SERVICE BULLETIN

No. 521

Piper Aircraft Corporation

<u>Subject:</u>	Inspection of Stabilizer Stringer Attachment
<u>Models Affected:</u>	<u>Serial Numbers Affected:</u>
PA-31 and PA-31-325 Navajo	31-7612060 to 31-7612080 Inclusive, 31-7612082 to 31-7612089 Inclusive, 31-7612091, 31-7612096, and 31-7612099.
PA-31-350 Navajo Chieftain	31-7652105 to 31-7652115 Inclusive, 31-7652117, 31-7652118, 31-7652120 to 31-7652146 Inclusive, 31-7652148 to 31-7652162 Inclusive, 31-7652164, 31-7652165 and 31-7652168.
<u>Compliance Time:</u>	At the next scheduled Programmed Inspection Event, not to exceed the next fifty (50) hours of operation.

TOP VIEW OF LEFT STABILIZER SHOWN - RIGHT OPPOSITE

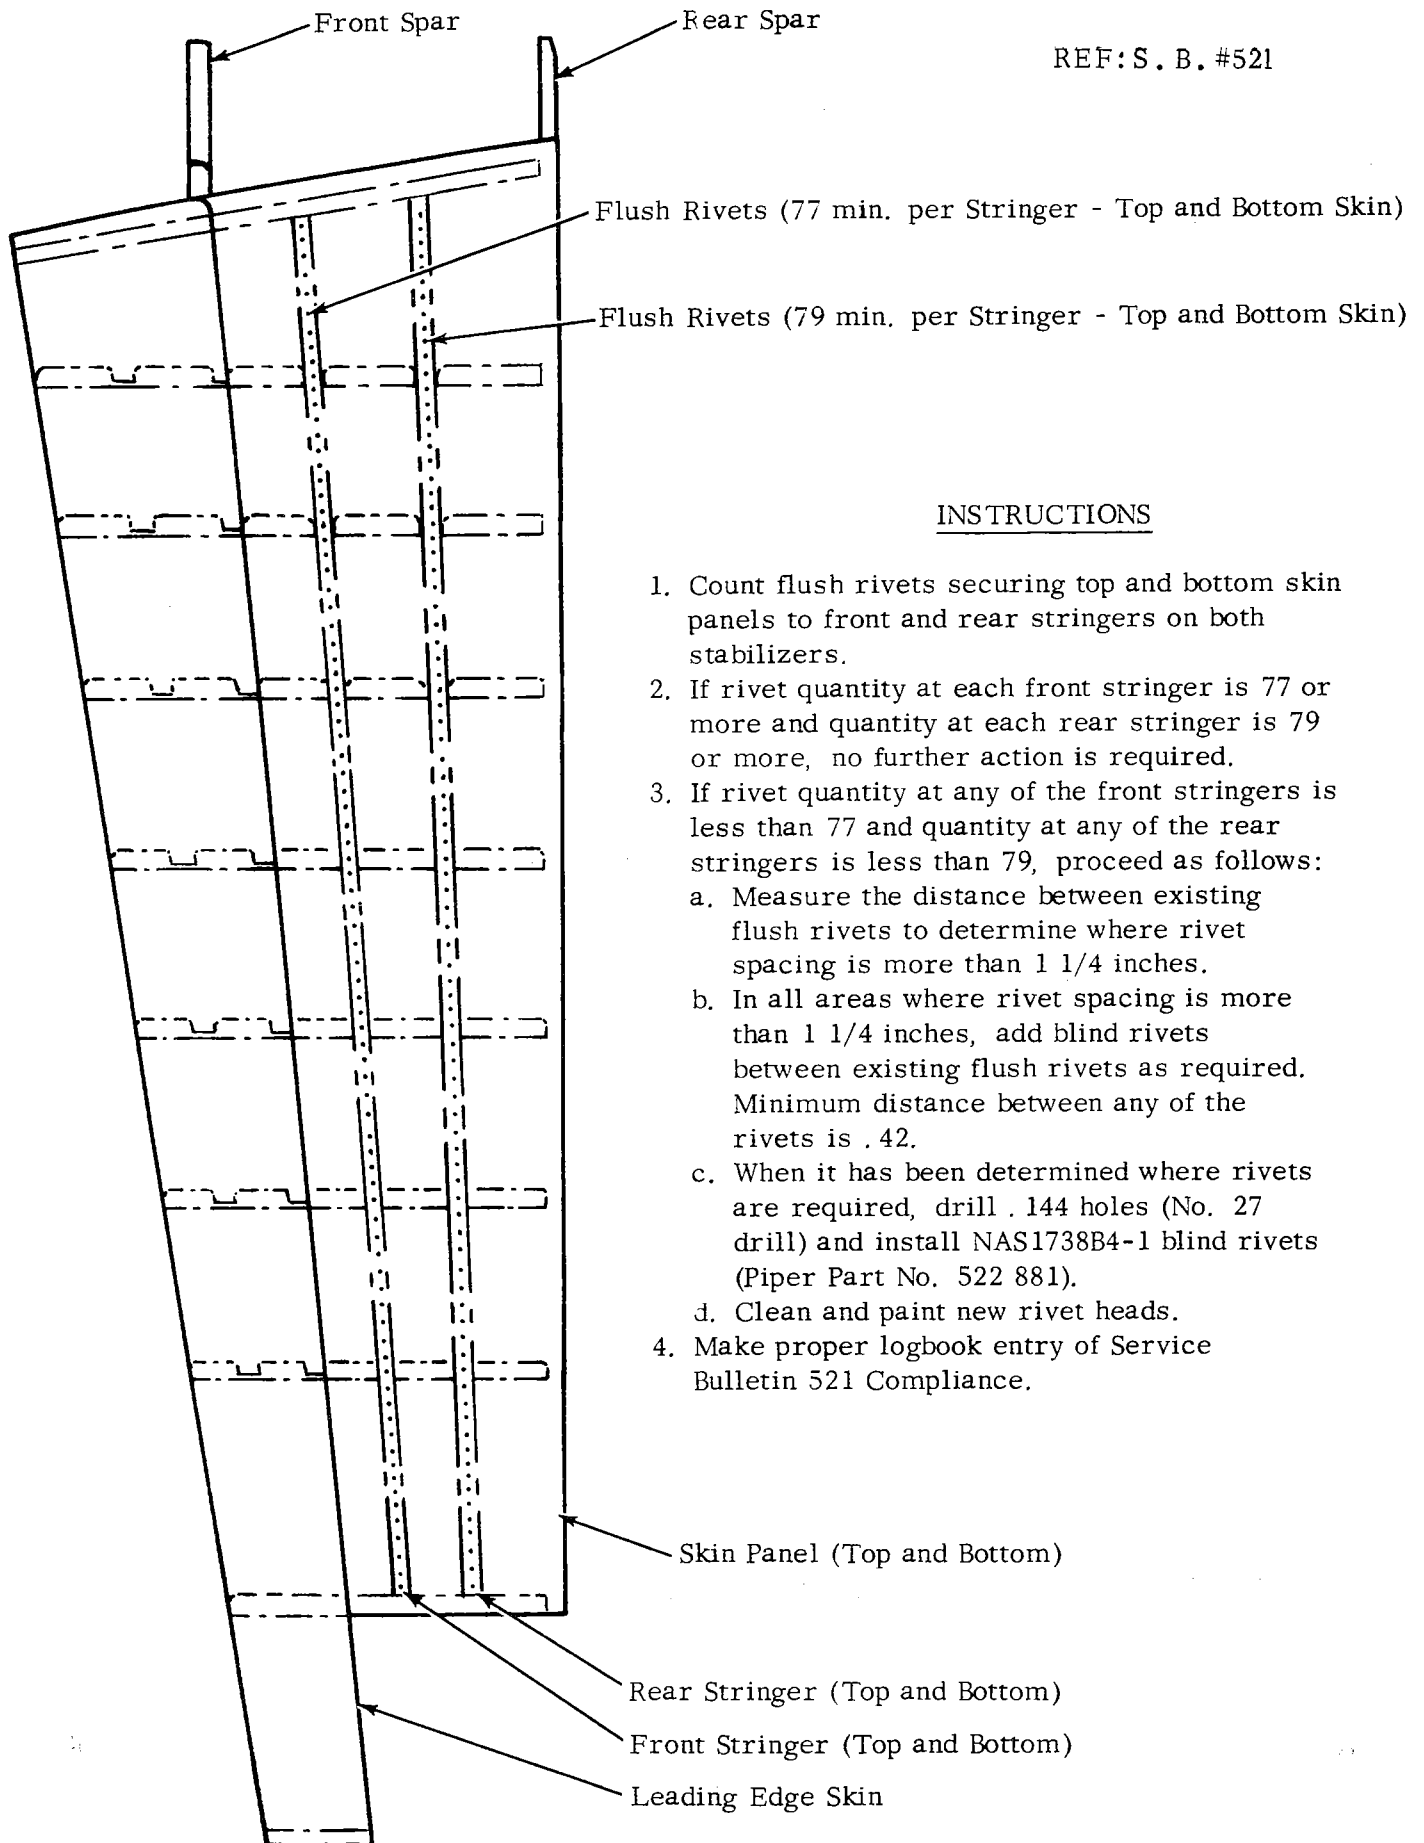
It has been found that an inadequate number of rivets may have been used to attach the stringers to the top and bottom skin panels. An inadequate number of rivets may permit local buckling of the skin between rivets. See attached sketch/instruction data for an illustrated view of the subject area.

This service release provides instructions to inspect the stabilizer skin stringer attachment in the areas described above and depicted on the attached sketch/instruction sheet to insure that an adequate number of rivets are installed.

1. Count flush rivets securing top and bottom skin panels to front and rear stringers on both stabilizers.
2. If rivet quantity at each front stringer is 77 or more and quantity at each rear stringer is 79 or more, no further action is required.

3. If rivet quantity at any of the front stringers is less than 77 and quantity at any of the rear stringers is less than 79, proceed as follows:
 - a. Measure the distance between existing flush rivets to determine where rivet spacing is more than 1 1/4 inches.

- b. In all areas where rivet spacing is more than 1 1/4 inches, add blind rivets between existing flush rivets as required. Minimum distance between any of the rivets is .42.

- c. When it has been determined where rivets are required, drill .144 holes (No. 27 drill) and install NAS1738B4-1 blind rivets (Piper Part No. 522 881).

- d. Clean and paint new rivet heads.
4. Make proper logbook entry of Service Bulletin 521 Compliance.
